NOTICE OF DECISION

CLASS 3 SITE PLAN REVIEW / CLASS 2 ADJUSTMENT CASE NO.: SPR-ADJ21-32

SUMMARY: A proposal to improve ADA and pedestrian access throughout the development site.

ADA PARKING UPGRADES
KAISER PERMANENTE
SKYLINE MEDICAL OFFICE
5125 SKYLINE RD S, SALEM, OREGON
CONSTRUCTION DRAWING SET

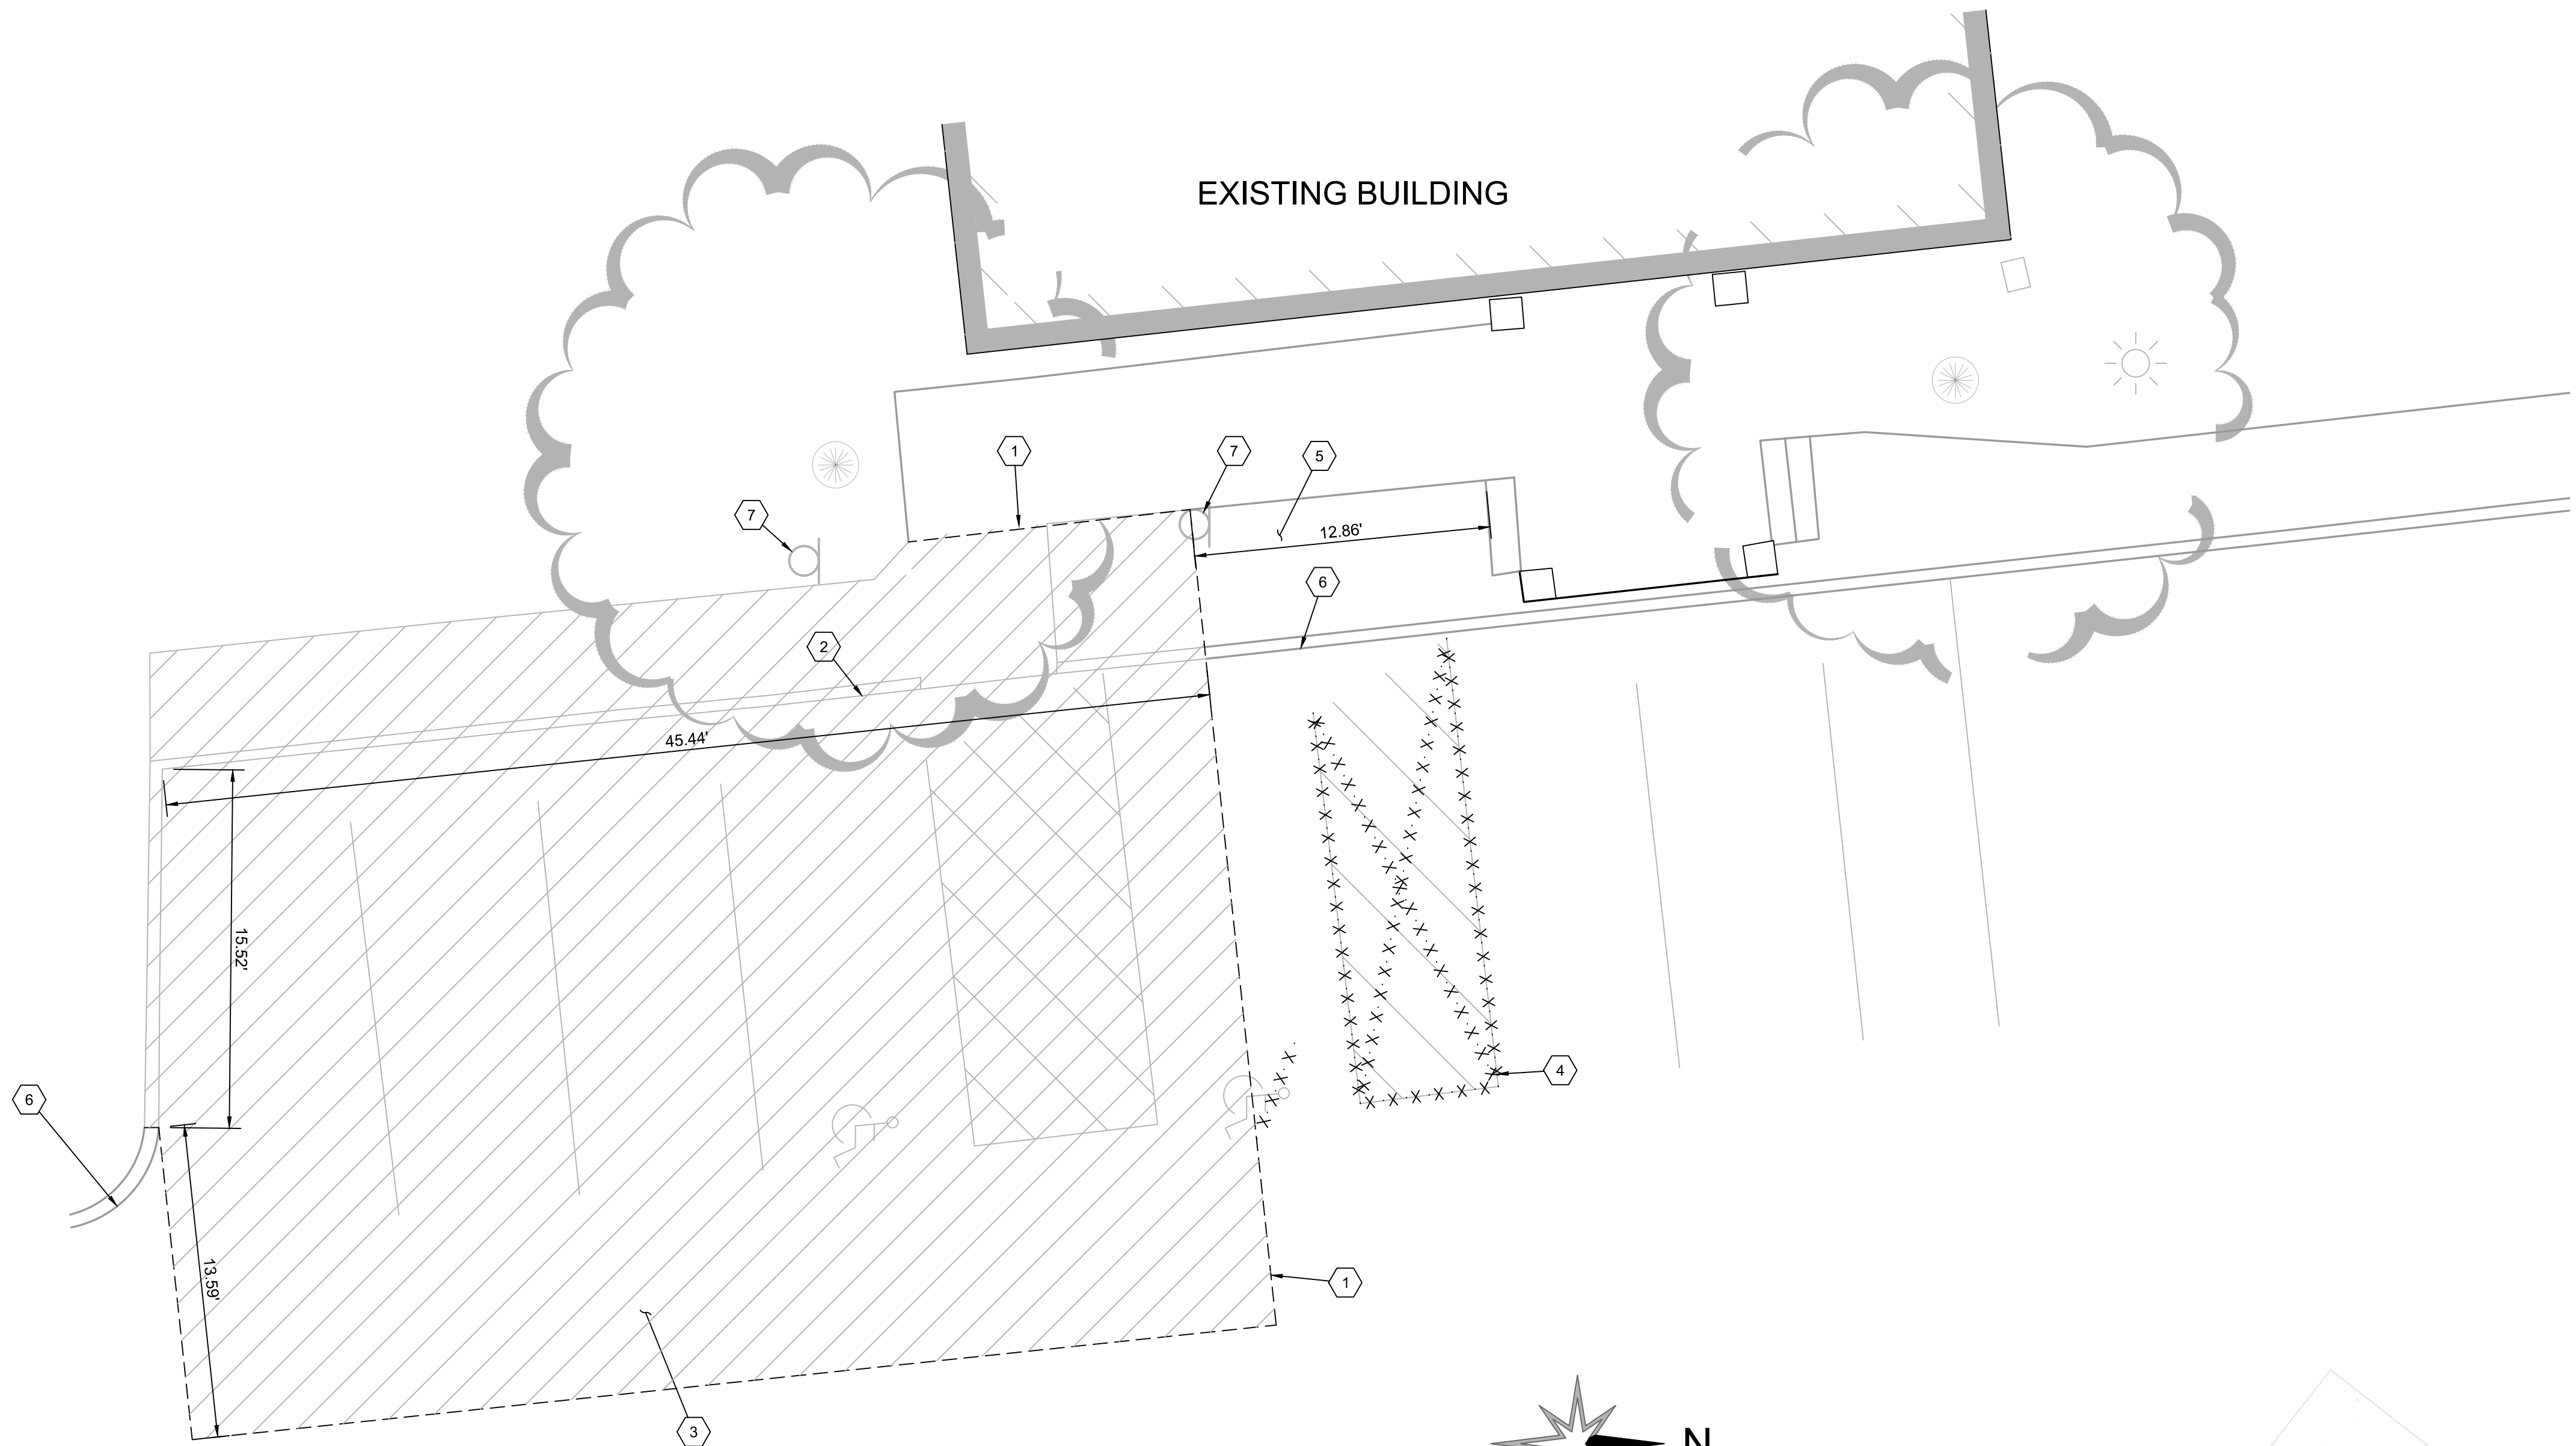
The off-street parking area on the northwest side of the driveway taking access from Skyline Road S is approximately 41,800 square feet in size. The site plan does not show a pedestrian connection that goes through the parking area. The applicant has requested an adjustment to this standard that is addressed below in the Class 2 Adjustment criteria.

Finding: The proposed site plan shows pedestrian walkways that meet the materials, width, and other standards of this section and walkways that do not. The walkways cross two drive aisles in the central portion of the site that do not provide for visual difference from as they pedestrian walkways are only stripped with no physical separation. To ensure conformance with this standard the following condition of approval shall apply:

The applicant has requested a Class 2 Adjustment to remove the requirement for a pedestrian accessway through the northern most off-street parking area pursuant to SRC 800.065(a)(3)(A). In summary, the applicant's written statement (**Attachment C**) indicates that the proposal equally or better meets the purpose underlying the development standard proposed for adjustment. They state that, because a pedestrian connection is being provided to Kuebler Boulevard S, on the northern portion of the off-street parking area, that this standard is equally or better met as then the sidewalks can be used to provide pedestrian connections to the outermost portions of the parking area.

Condition 1: All pedestrian walkways crossing driveways, parking areas, parking lot drive aisles and loading areas shall be visually differentiated from such areas through the use of elevation changes, a physical separation, speed bumps, a different paving material, or other similar method. Striping does not meet this requirement unless combined with speed bumps and striping.

Staff concurs with the applicant's findings. As displayed on the site plan no pedestrian connection currently exist that provides direct access to Kuebler Boulevard S. By providing the connection to Kuebler Boulevard S the applicant is able to comply with SRC 800.065(a) that requires a pedestrian connection from primary building entrances to abutting streets. Further, in providing this connection the applicant enables use of the abutting sidewalks that bound the northern most parking lot providing pedestrian access, free from vehicle traffic, to the furthest portions of the off-street parking area. In doing this, the remaining portions of the parking area are within 124 feet of the existing pedestrian connections and would be exempt from the pedestrian connections [see SRC 800.065(a)(3)(A)(iv)] if it were not for size of the off-street parking area. By providing access to the surrounding sidewalks staff concurs that the intent of standard is equally or better met by the proposed development. This criterion is met.
